Subject: Residential Property Engineering Inspection - 946 River Landing Dr, Memphis, TN 38103

1. Foundation and Slab Assessment

05/26/2026 OZER DATA:
RELATIVE SLAB ELEVATION

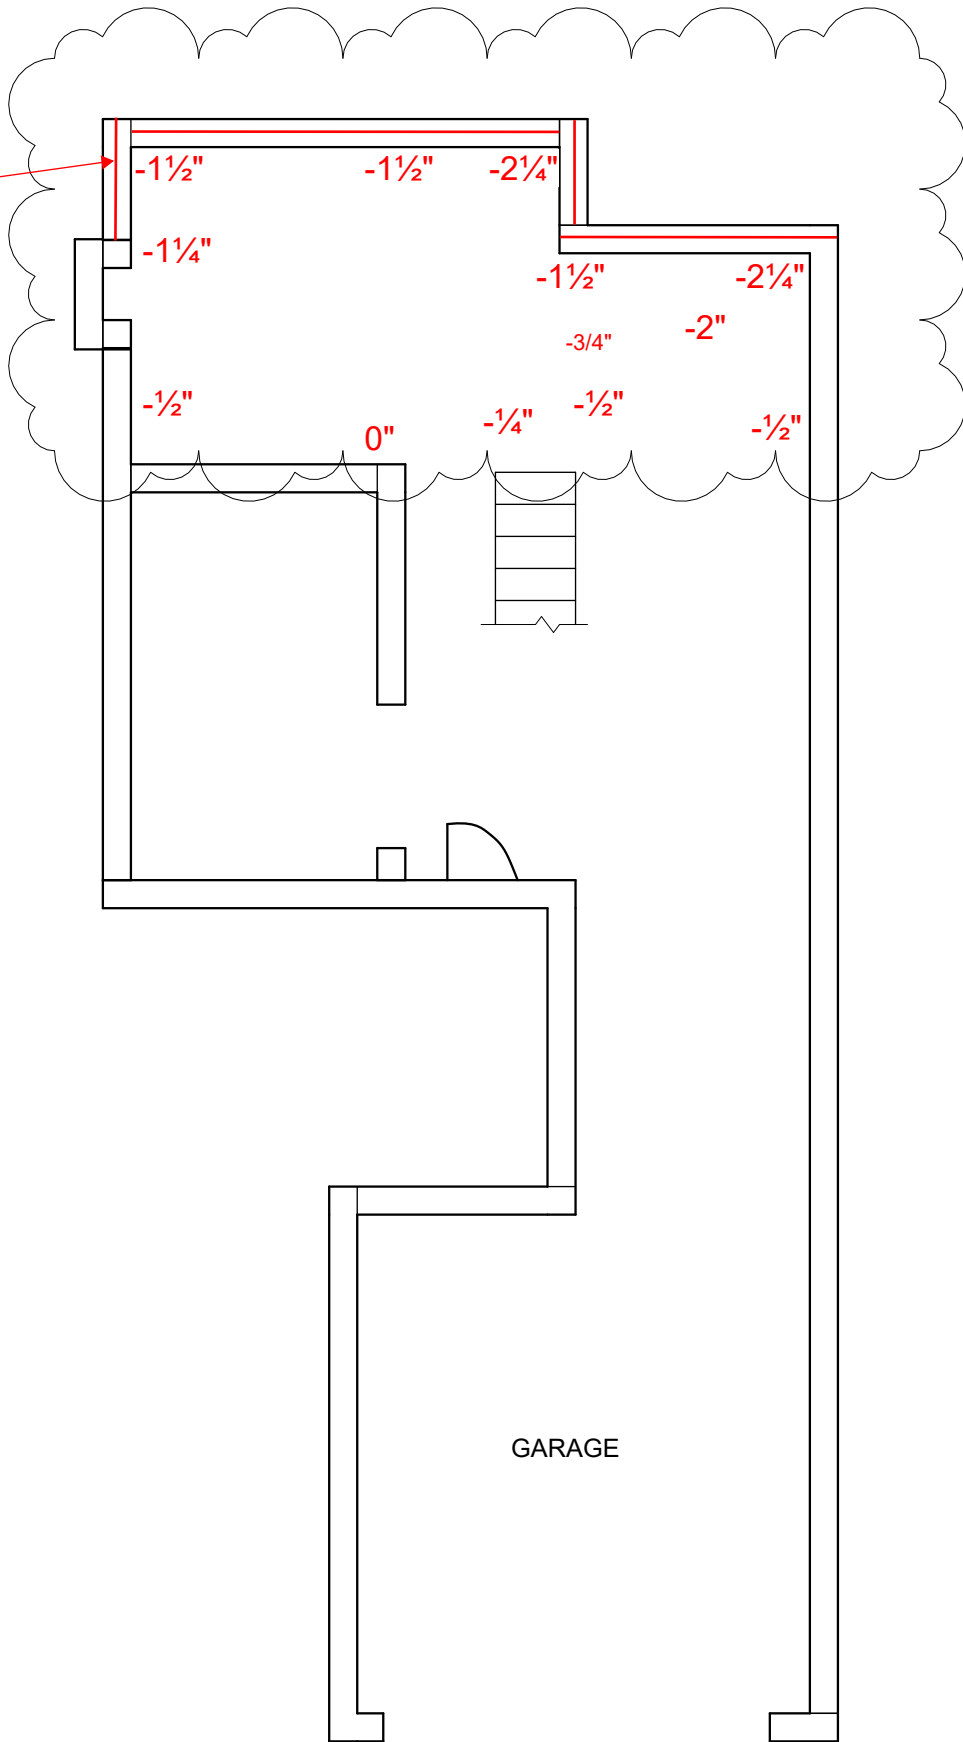
- **Slab and Perimeter Lifting:**
- Raising the slab should be accompanied by perimeter pier adjustment to avoid significant dips at perimeter once slab is leveled.
 - **Raise Perimeter Piers:** The homeowner should contact the foundation repair company who installed the piers, s and instruct them to raise their perimeter piers 1½ inches. The piers should be raised uniformly in increments to minimize damage to the house.
 - **Polyurethane Injection:** Once the perimeter piers are raised, injecting high-density polyurethane beneath the affected slab area is an economical and viable method to achieve interior slab lift and support, provided the subgrade remains stable.

Red line is where
perimeter needs to
be raised
